# **REVIEW OF APPLICATION FOR RE-CERTIFICATION BY THE LOW IMPACT HYDROPOWER INSTITUTE OF THE WORNOCO HYDROELECTRIC FACILITY, LIHI #68**

Prepared by Patricia McIlvaine  
May 18, 2020

# Woronoco Recreational Facilities

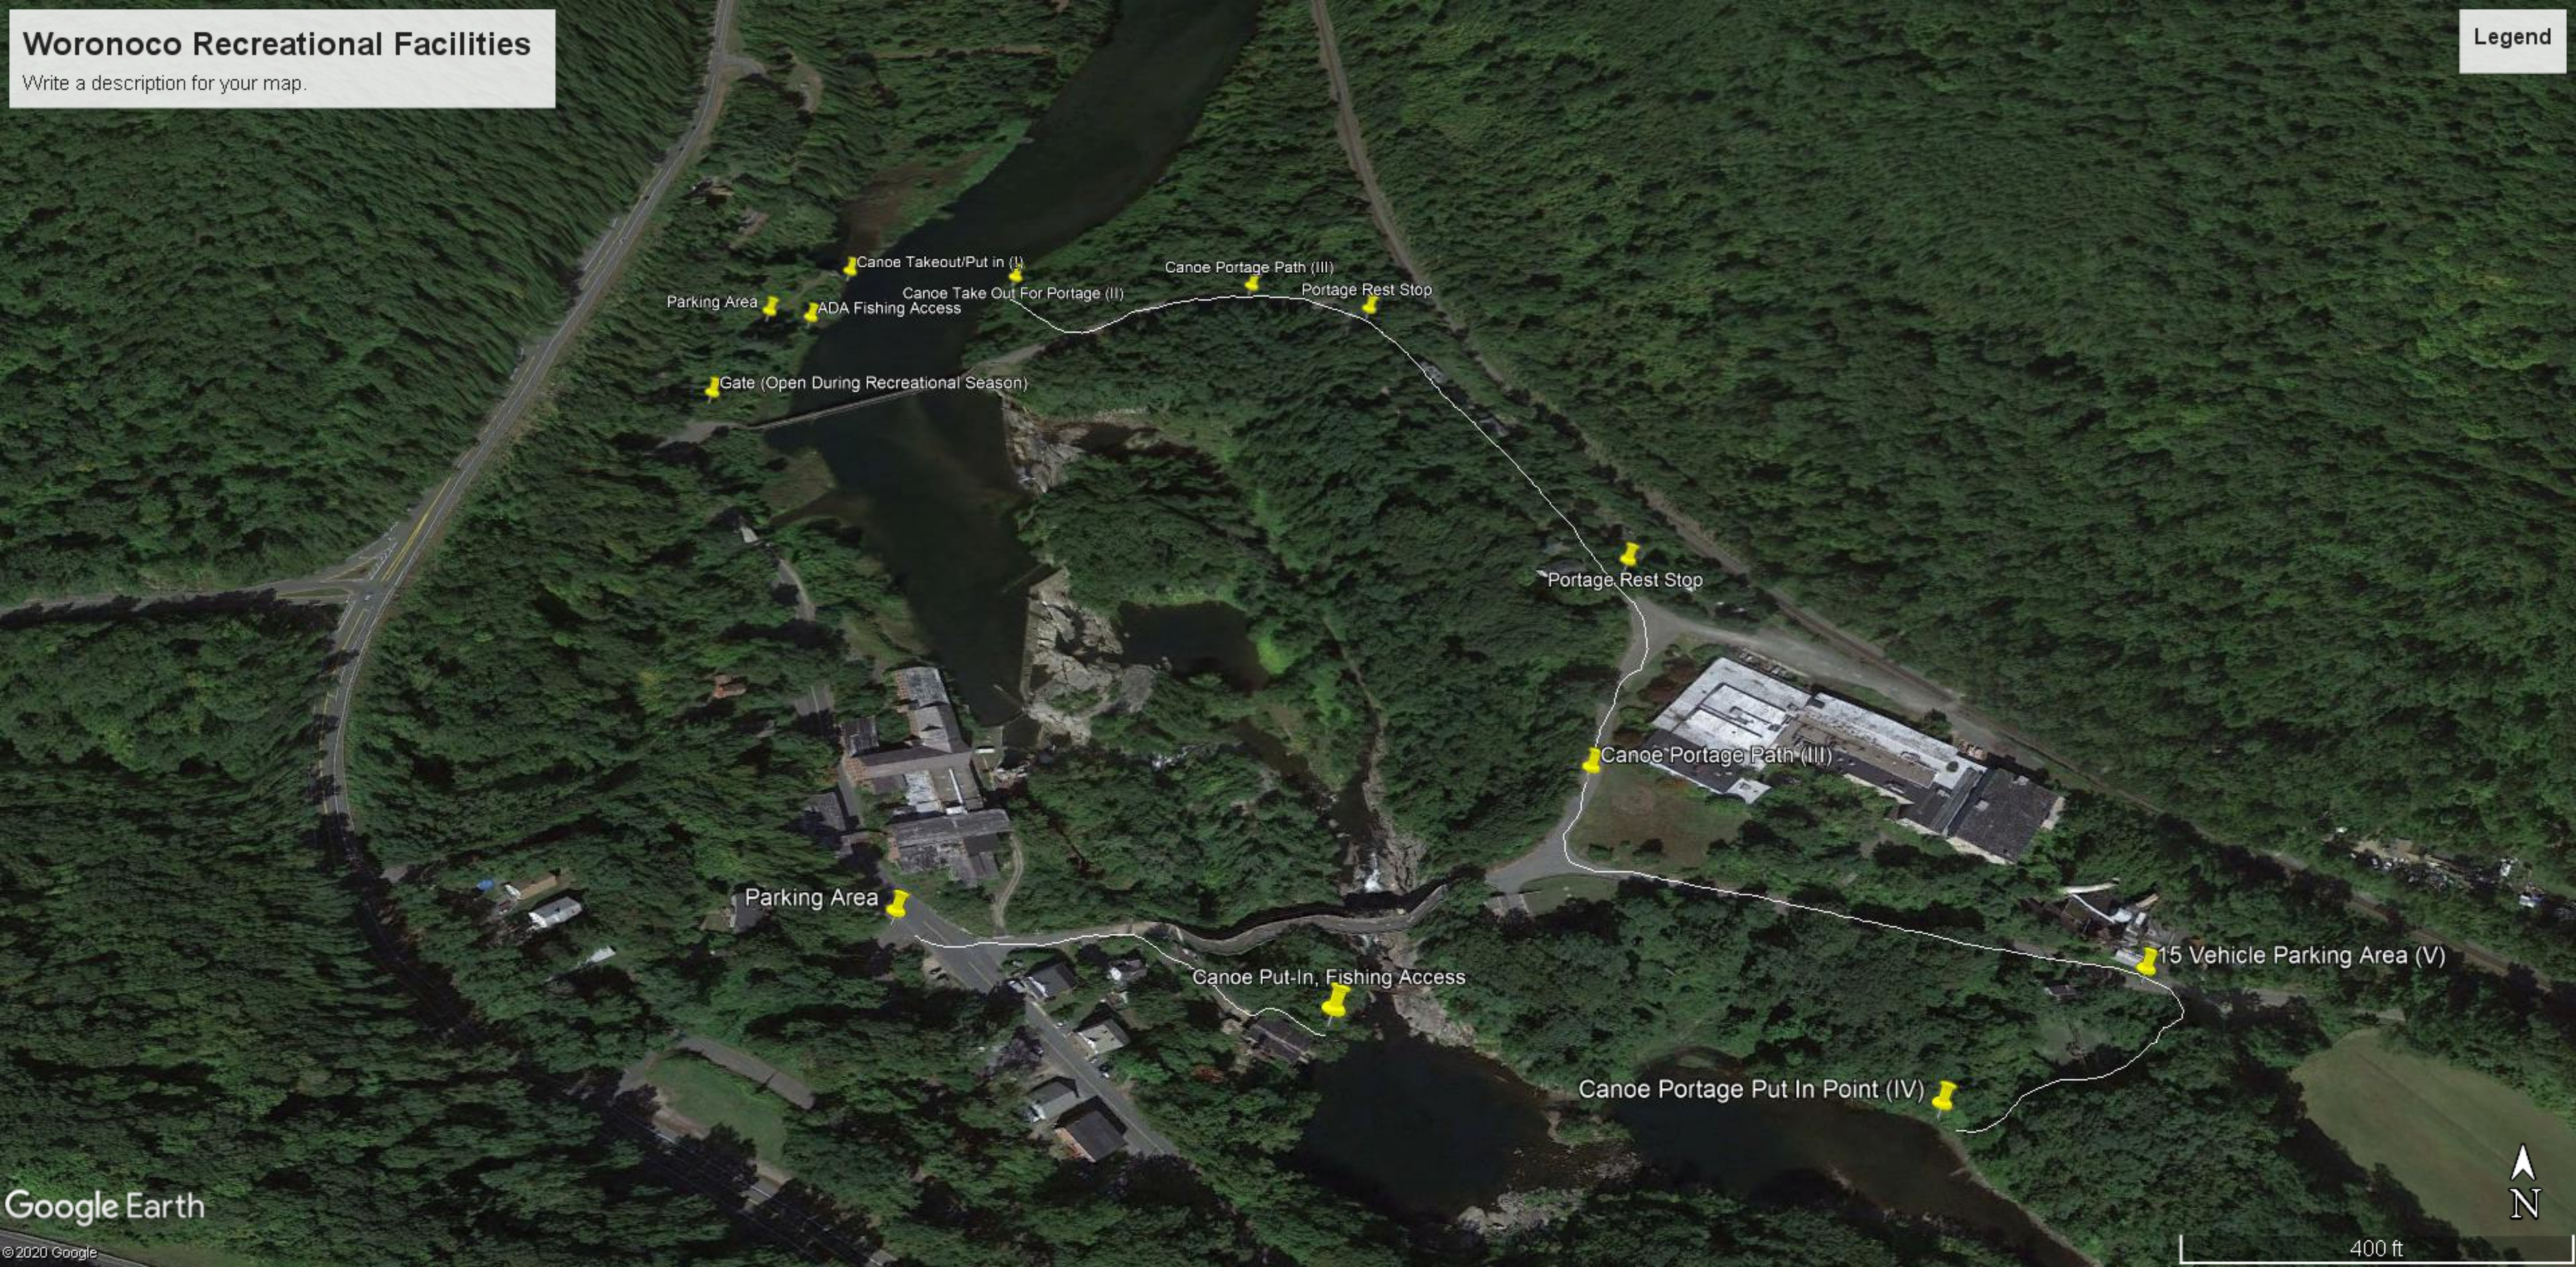
Thanks to one of the board members from the Westfield River Watershed Association who went to check out the recreation facilities today, it appears that some of the recreation facilities need some attention. Overall, she reported that it is very confusing trying to figure out where the recreational sites are. The put-in and takeout on the west side of the river in the impoundment (requirement #1 above) has a dilapidated platform that does not sound like the ADA fishing spot described in the plan. There are many no parking signs and it's not clear where the 15-vehicle parking area is. On the river left side (#2), the take-out has no parking signs all over the road. The portage route (#3) is not clear, one of the rest stops needs to be repaired, and at least one sign needs to be cleared of vines. The put-in downstream of the dam (#4 or 5) has a private property/no trespassing sign on the trail, and it's not clear if this is where the portage route is. If this is still a viable put-in location, signage indicating public access should be posted. Please see photos attached at the end of this letter.

*Eagle Creek should maintain and improve any recreation facility/sign shown to be in disrepair.*

- Eagle Creek's website was updated with the recreation opportunities available at the site and the location map included in the Recreation Plan filed with FERC was also uploaded to the website. No photos are included. Attached is a marked up aerial, for internal reference, that shows the locations of the recreation facilities. The numbering correlates to FERC's approval of the Recreation Plan. Woronoco also maintains an additional recreation area downstream of the powerhouse on river right for fishing access, that was not included in the recreation plan filed or approved by FERC.

- As part of the seasonal clean-up that Woronoco starts at the beginning of the recreation season, Woronoco will remove vegetation, open the gate, replace any missing or damaged signs and improve trails / parking areas. The ADA fishing structure remains in the location that it has been since it was first installed, however, the site has proven to be difficult for fishing due to the presence of silt and soft soils that have accumulated between the fishing structure and the river's edge. Woronoco will further evaluate the current site's condition and determine its suitability for continued use as an ADA fishing location. If unsuitable, Woronoco will evaluate various alternative areas near the Valley View Rd. bridge for ADA fishing access suitability.
